# JONES & BEACH ENGINEERS INC.

**RE: Response Letter- TRG Meeting Comments  
120 Marketplace Boulevard, Rochester, NH  
Tax Map 216, Lot 11  
JBE Project No. 21173**

# MIXED USE BUILDING "RIDGE MARKETPLACE"

DRAWING No.  
**C1**  
SHEET 2 OF 10  
JBE PROJECT NO. 21173

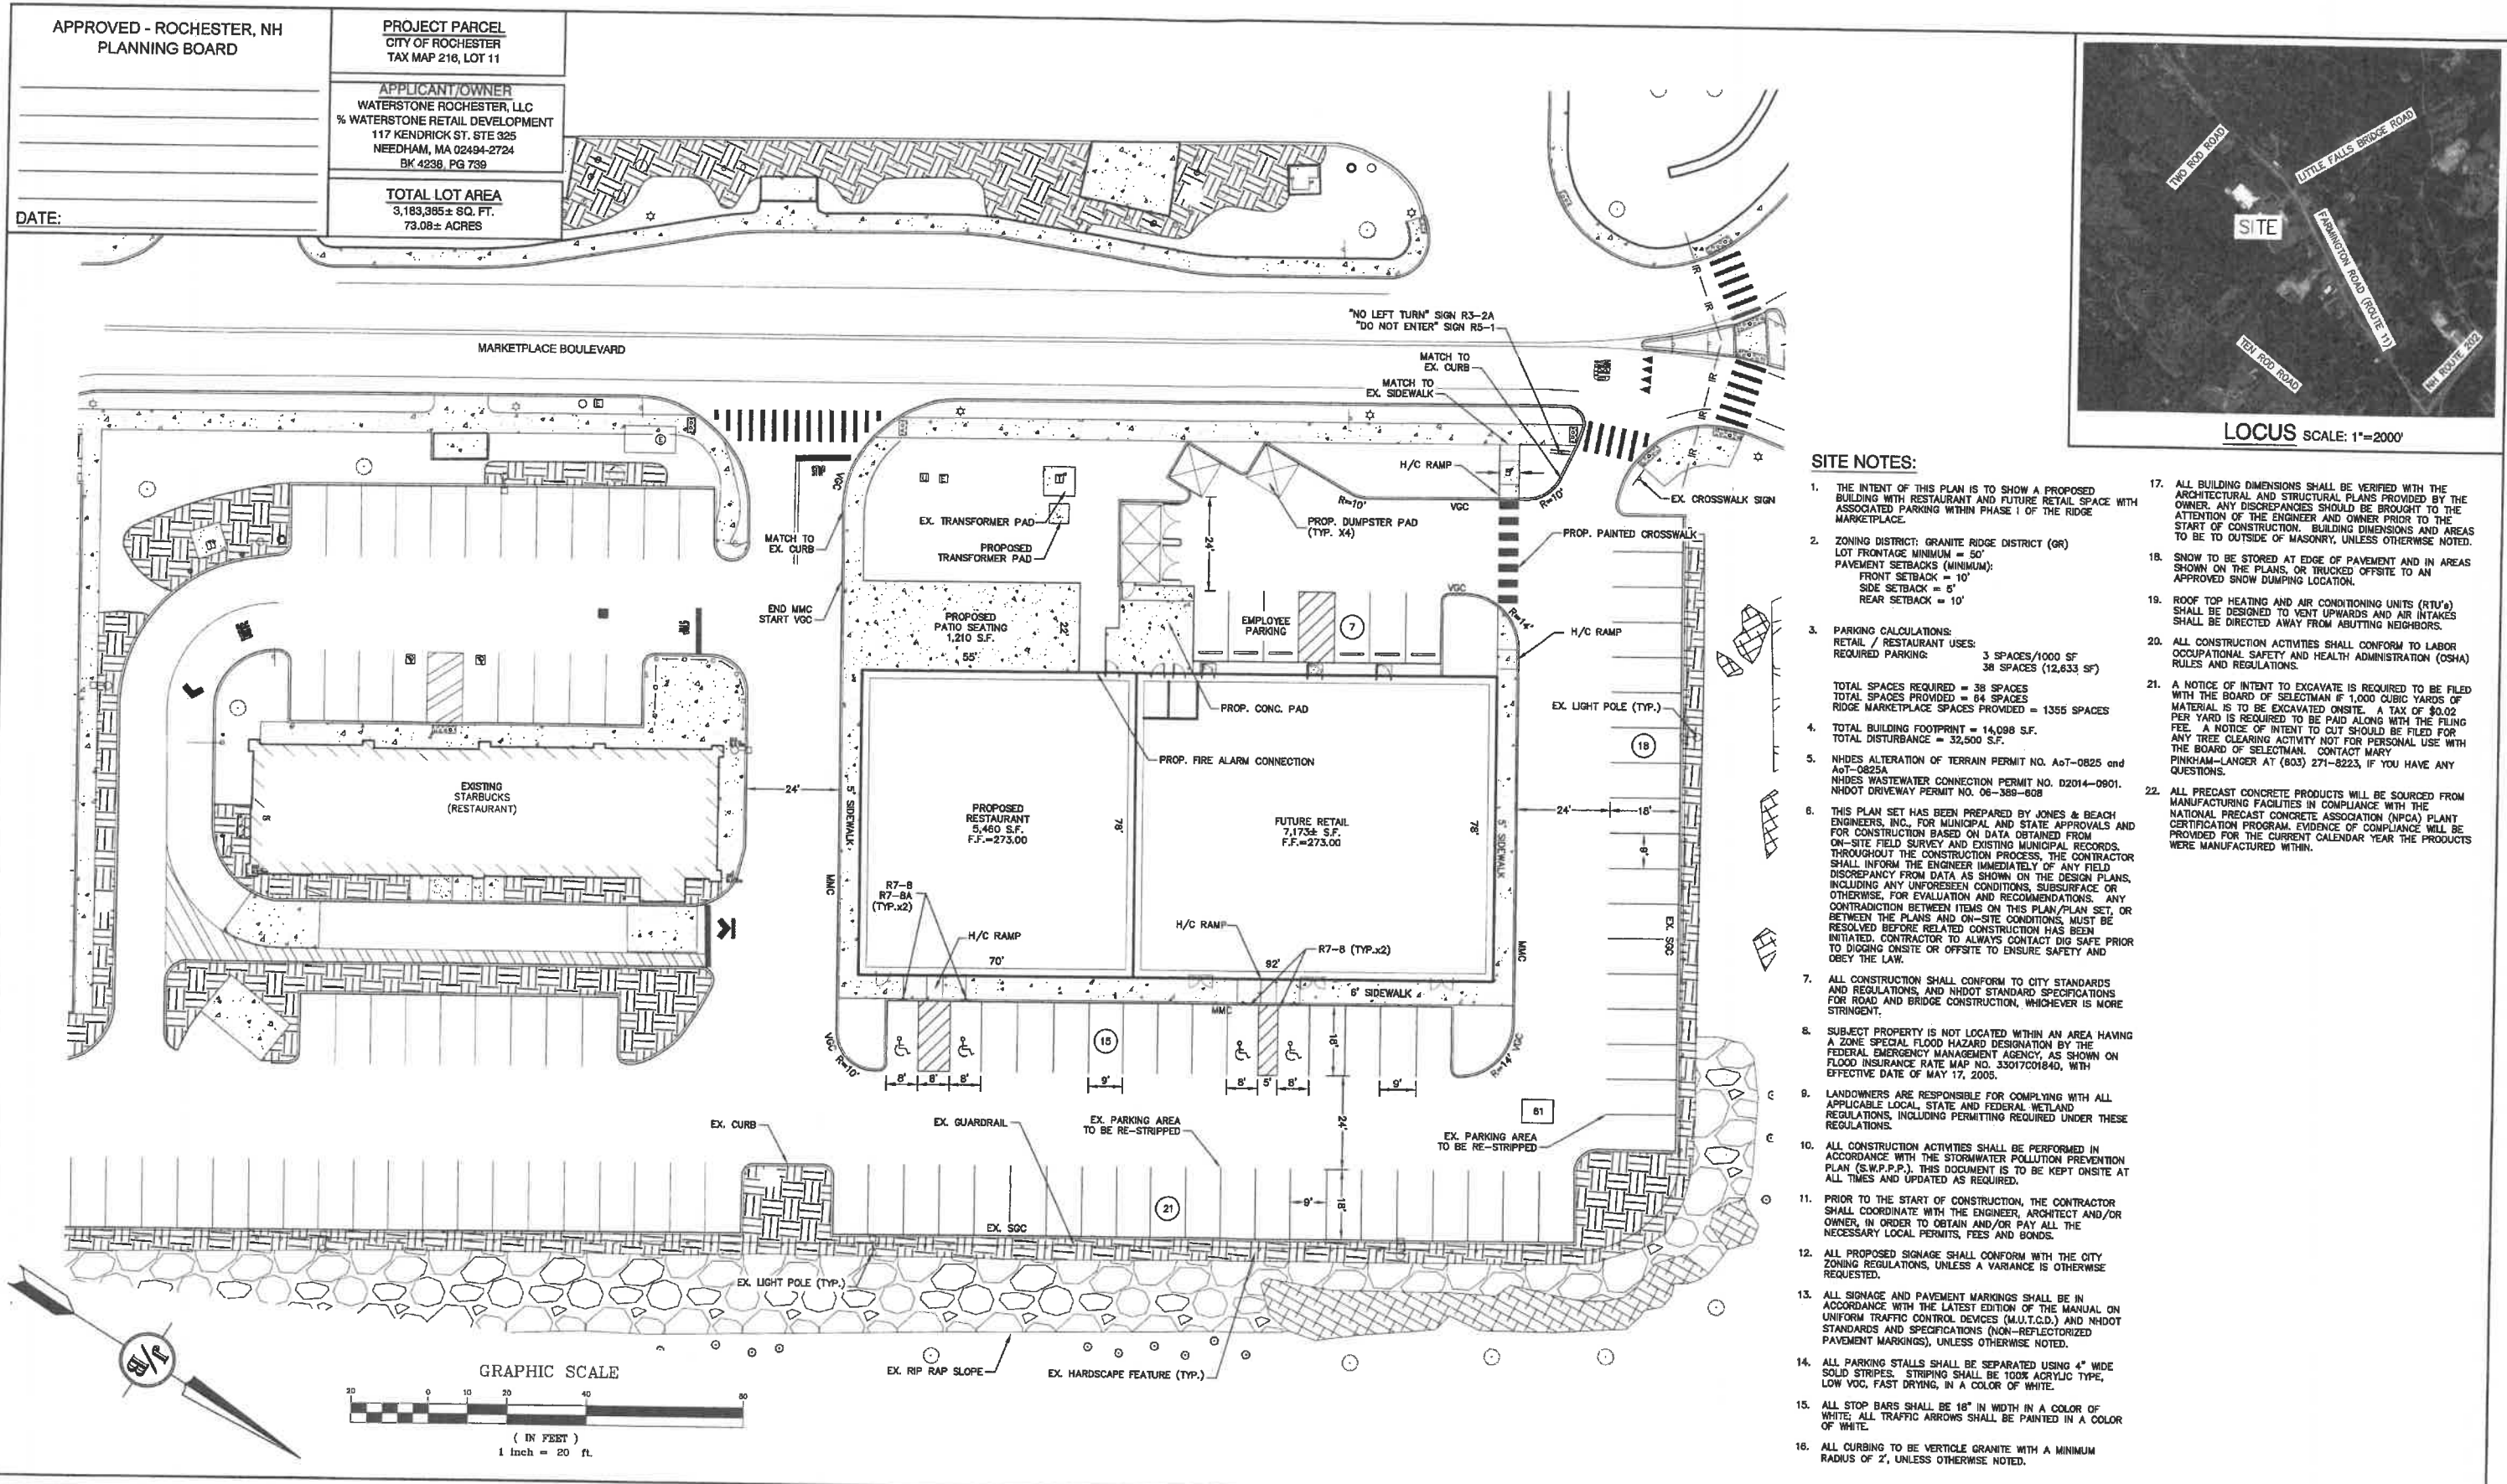
1. *The northerly exit/entrance from Marketplace Blvd closest to the traffic circle I would like to see a no left turn traffic sign posted for vehicle exiting using this driveway.*  
**RESPONSE:** A “no left turn” traffic sign & “do not enter” traffic sign will be posted in the applicable area. The signs are depicted on Sheet C2.
2. *Temporary construction fencing (when it comes to that point) should have no trespassing signs posted at least two on each side.*  
**RESPONSE:** The temporary construction fence will be put around the subject area. This is depicted on Sheets C1 & C3. No trespassing signs will be posted on each side of the fence. Note 5 on Sheet C1 has been added requiring the signage.

5. CONTRACTOR TO MOUNT "NO TRESPASSING" SIGNS ON ALL 4 SIDES OF CONSTRUCTION FENCE PERIMETER

DRAWING No.  
**C3**  
SHEET 4 OF 10  
JBE PROJECT NO. 21173

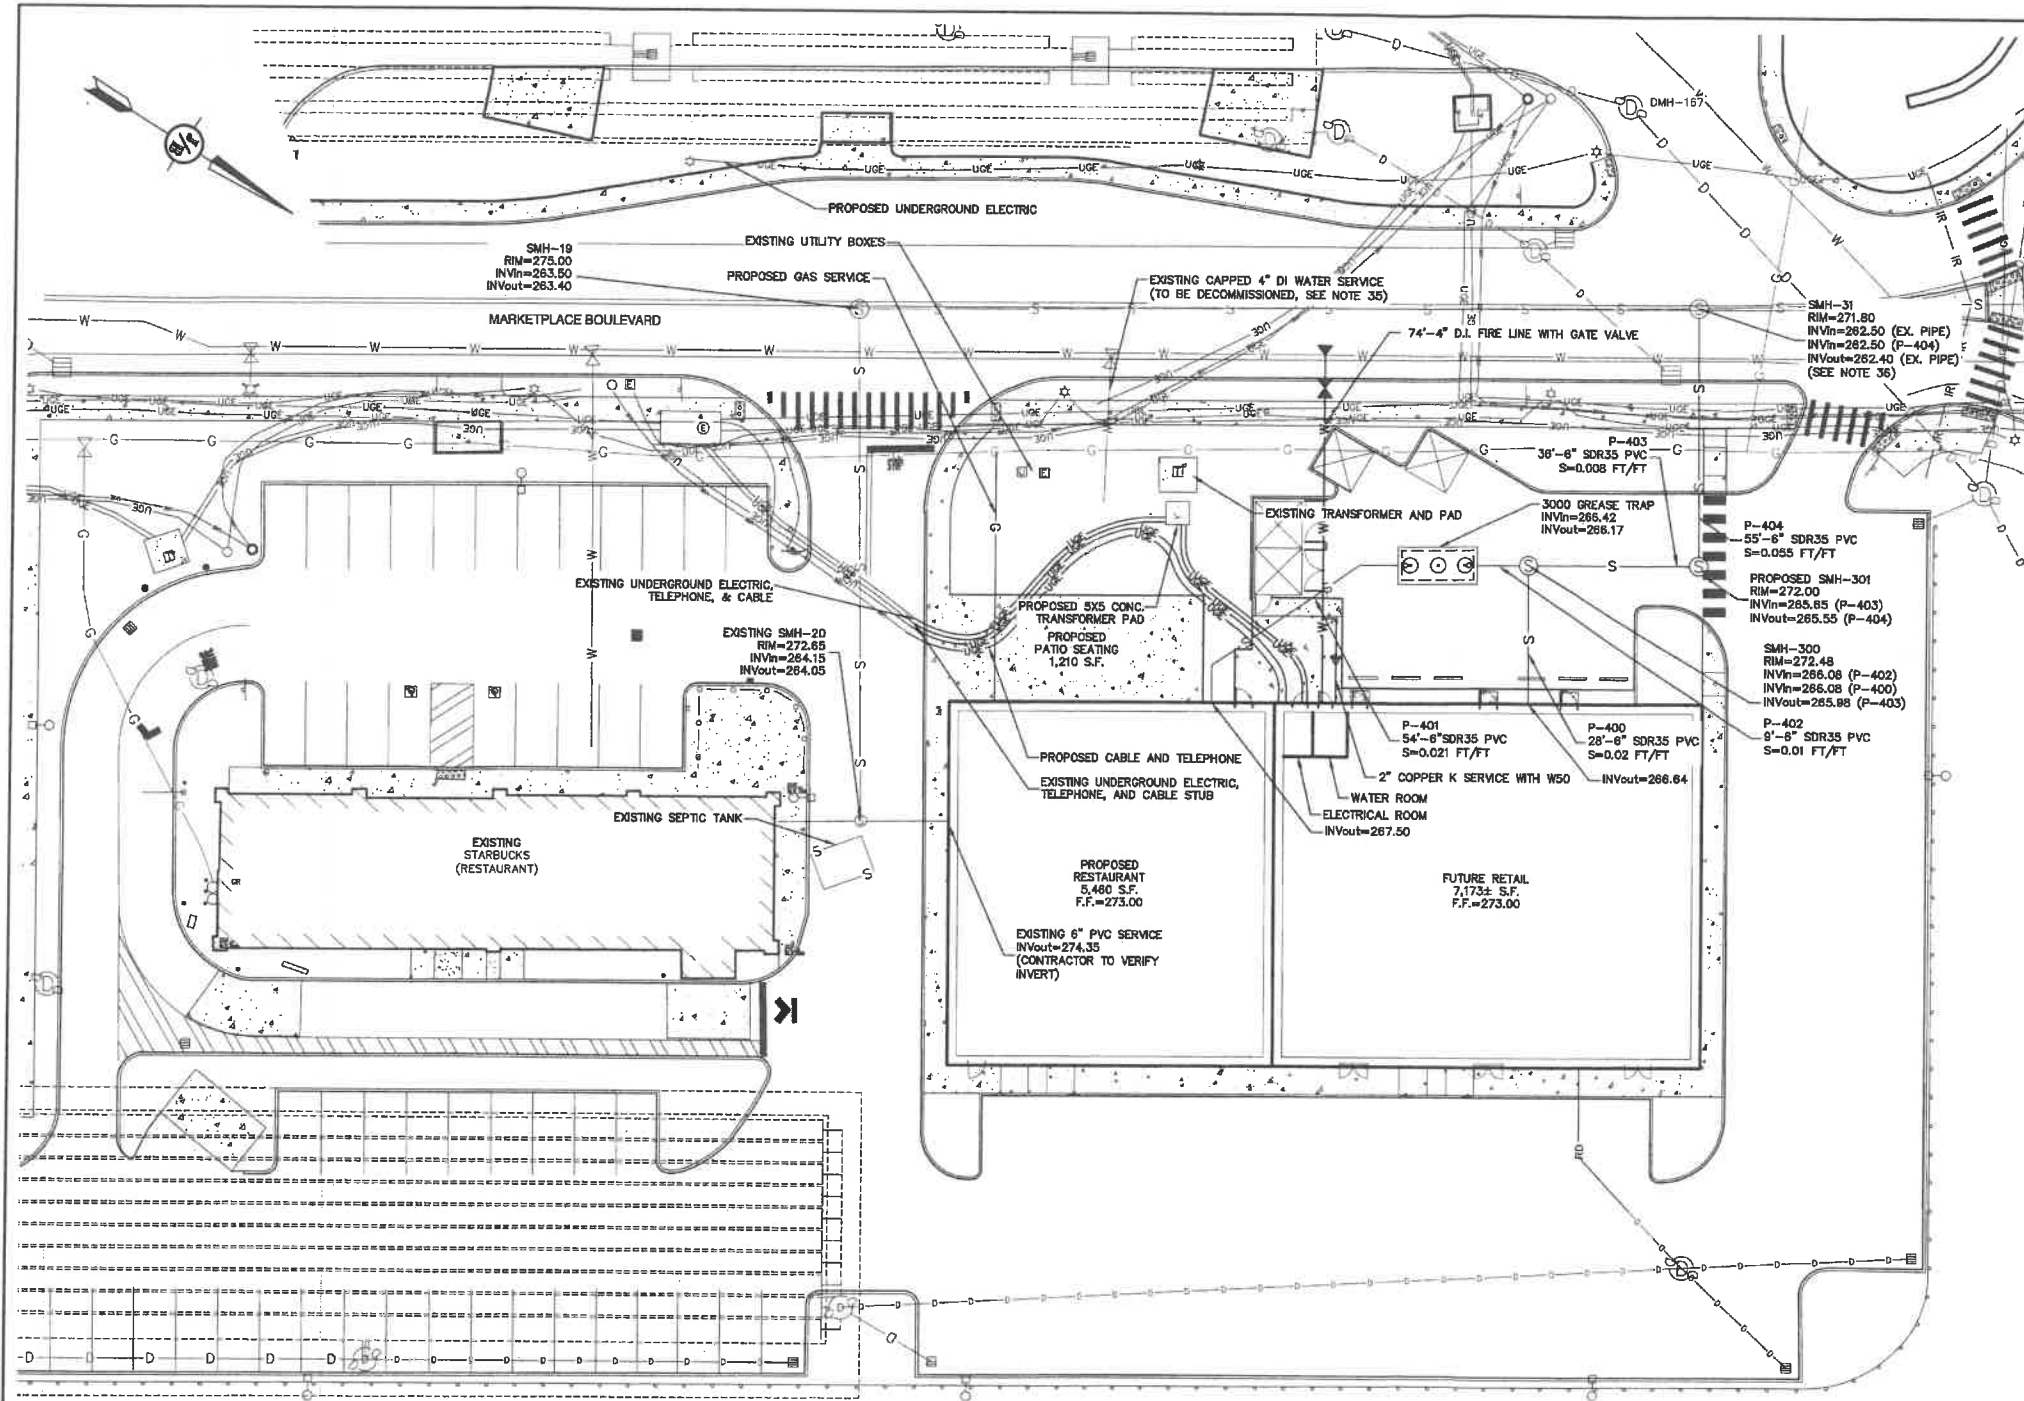
1. *Please ensure installed drainage is protected during construction and BMP are enacted for any stockpiling. All site disturbance and runoff must be confined to site boundaries, preferably using silt sock to protect the entrances and drainage.*  
**RESPONSE:** The installed drainage will be protected during construction with the use of silt sock and catch basin silt sack inserts. All site disturbance and runoff will be confined to the site boundaries using silt sock. A “Silt Soxx” detail has been added to Sheet E1. The silt sock has been depicted on Sheets C1 & C3.

DRAWING No.  
**C4**  
SHEET 5 OF 10  
JBE PROJECT NO. 21173

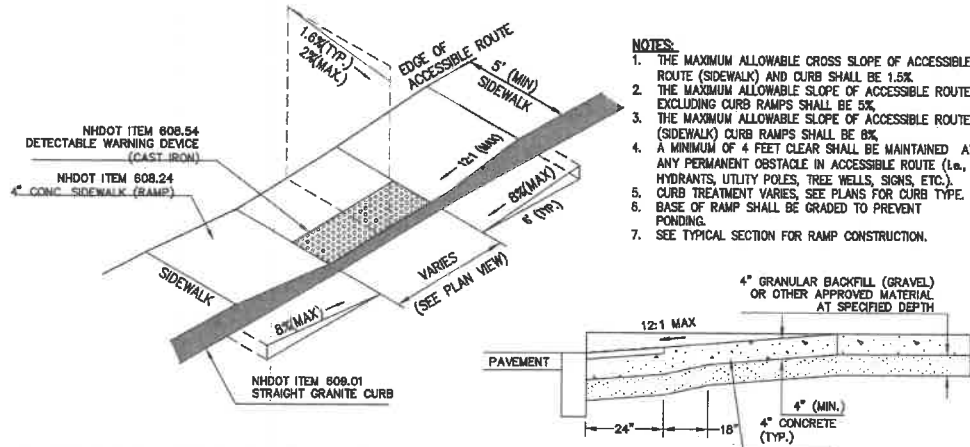
1. *SMH 31 should be used for the sewer connection on Marketplace Blvd. The brick shelf invert will need to be modified to accommodate the new service connection.*

3. *Please verify the size of the existing water service stub. If a new domestic/fire service line is required as shown on Sheet C4, then the existing water service stub will need to be properly abandoned per DPW requirements.*

**RESPONSE: SMH 31 will be used as the sewer connection and the brick shelf invert will be modified to accommodate the new service connection. See Note 36 on Sheet C4.**

**RESPONSE: The existing stub is a 4" DI fire water service. Note 35 on Sheet C4 has been added requiring DPE requirements are to be adhered to. This service stub can not be utilized due to the proposed uses requirement for a 6" fire service.**

- CONTRACTOR TO REMOVE WATER SERVICE BACK TO WATER MAIN PER CITY OF ROCHESTER DEPARTMENT OF PUBLIC WORKS STANDARDS.
- CONTRACTOR TO MODIFY BRICK SHELVE INVERT AT BOTTOM OF SMH-31 TO DIRECT SEWER FLOW.

SCHEMATIC EXT. ELEVATIONS

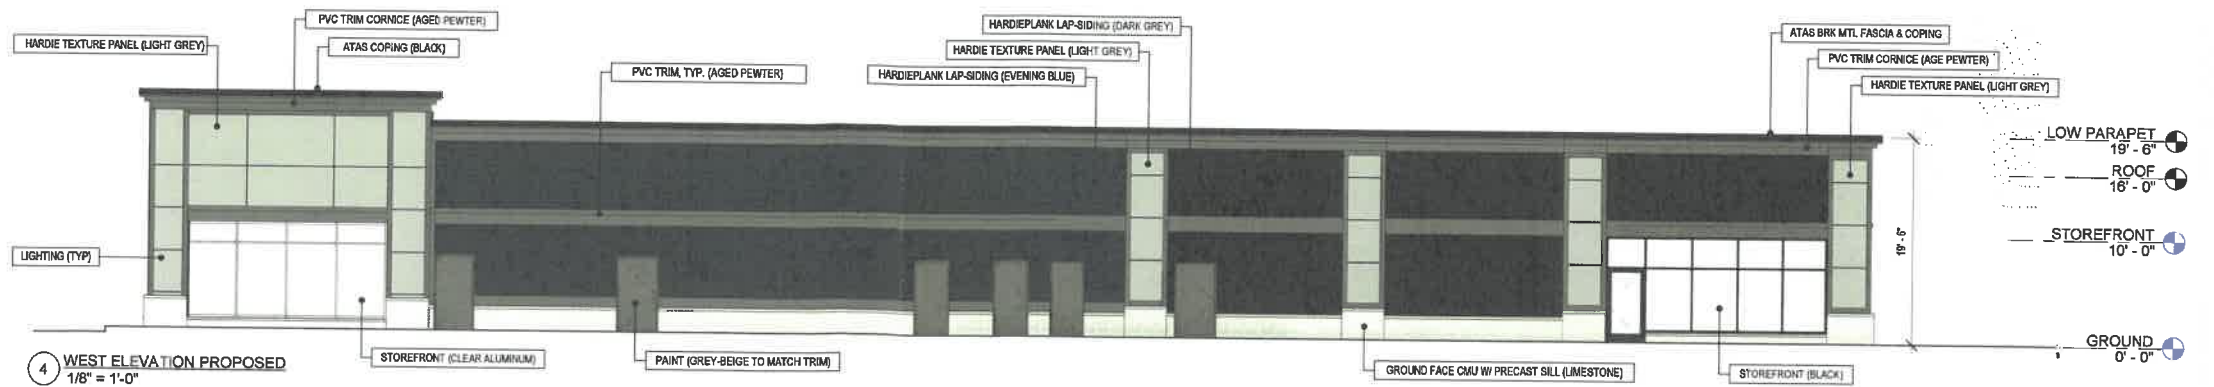
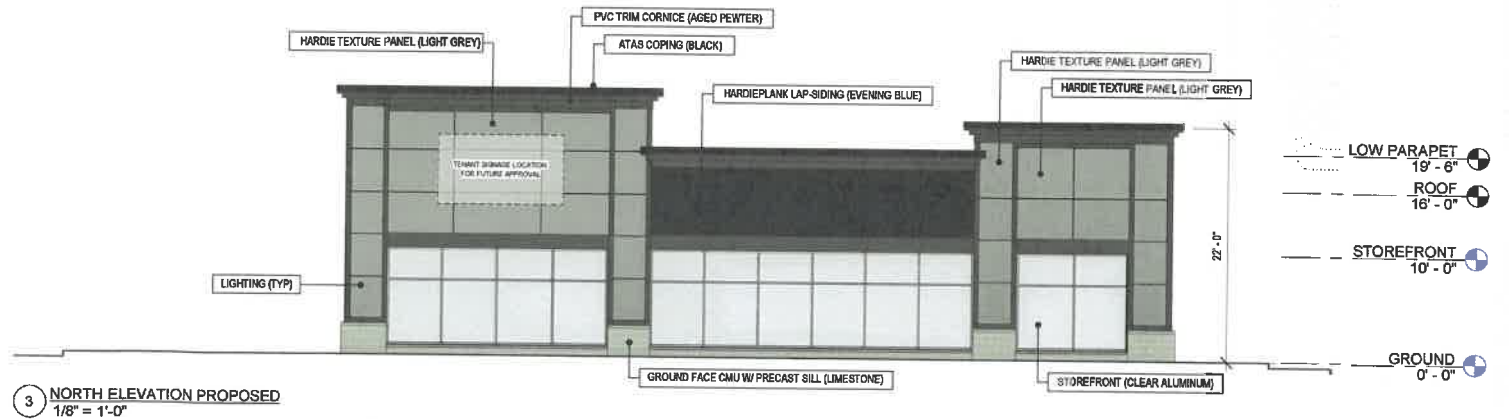
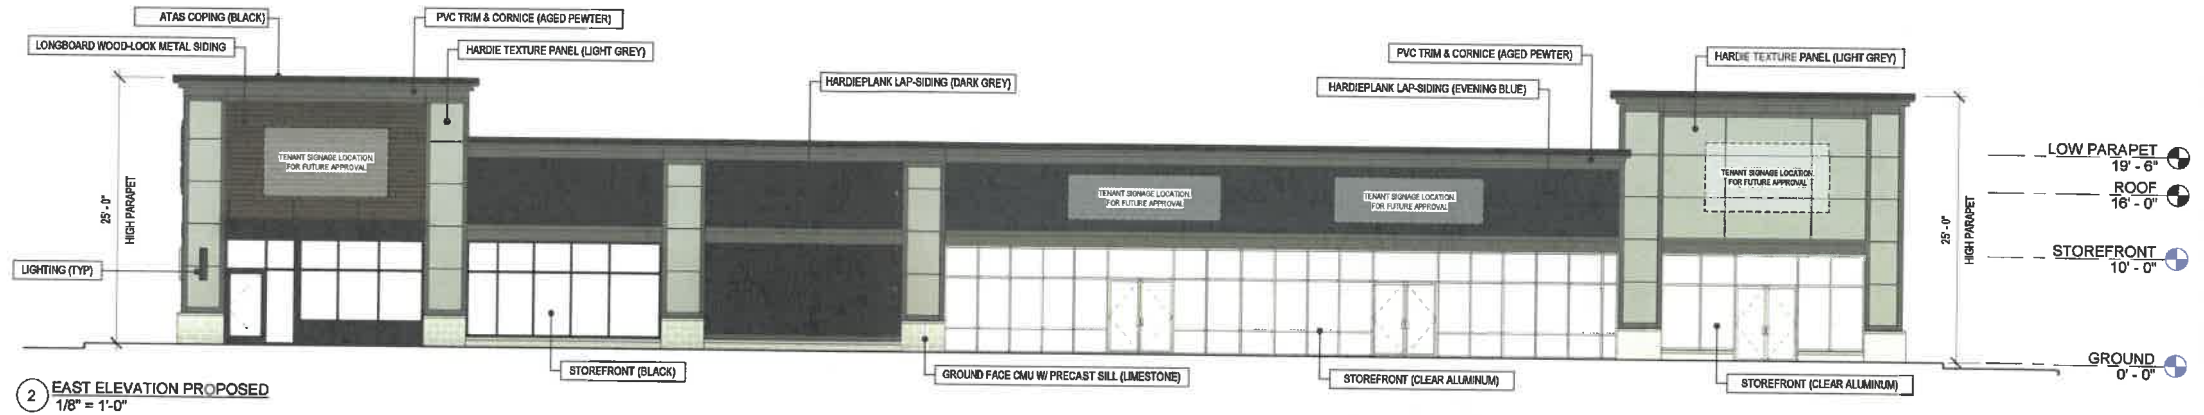
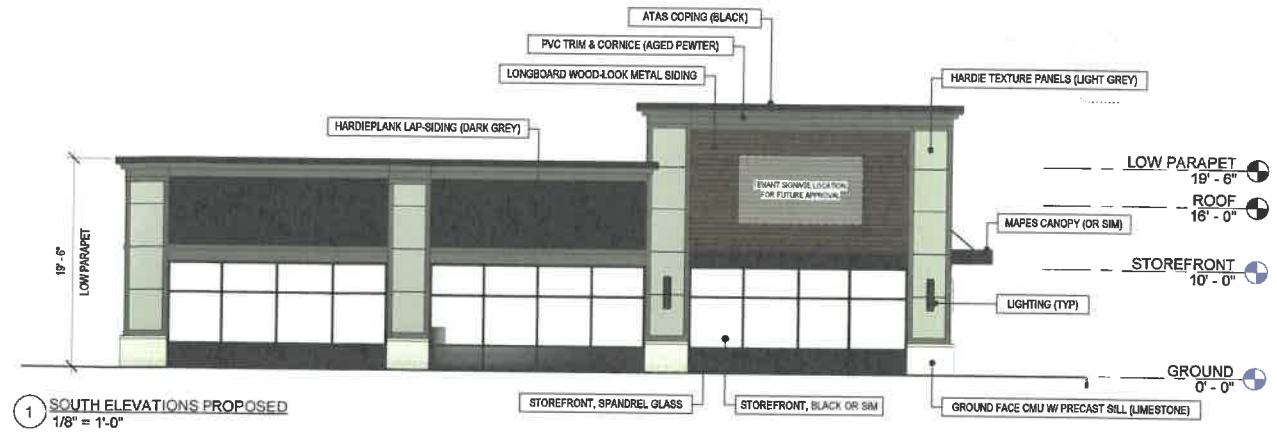
2. *Architectural Design:*
  - a. *Please specify window treatments. The goal is to ensure a balance of windows to façade, especially for the retail side where the rendering showed mostly window coverings. We also understand windows may be covered during construction or until the space is occupied and are looking to confirm the long-term plan fits with the overall design.*

**RESPONSE:** The retail glass façade would be clear low-e insulated glazing. The design goal of the glass façade, that is not part of the proposed restaurant, was to provide the landlord an elevation with the most flexibility to allow for an unknown mix of potential number of tenants for this space. Currently there are no proposed tenants for this space. After shell construction, if there are no tenants for the proposed space, a graphic vinyl

window treatment will be installed into the windows so that the view into an unfinished space would be obscured.
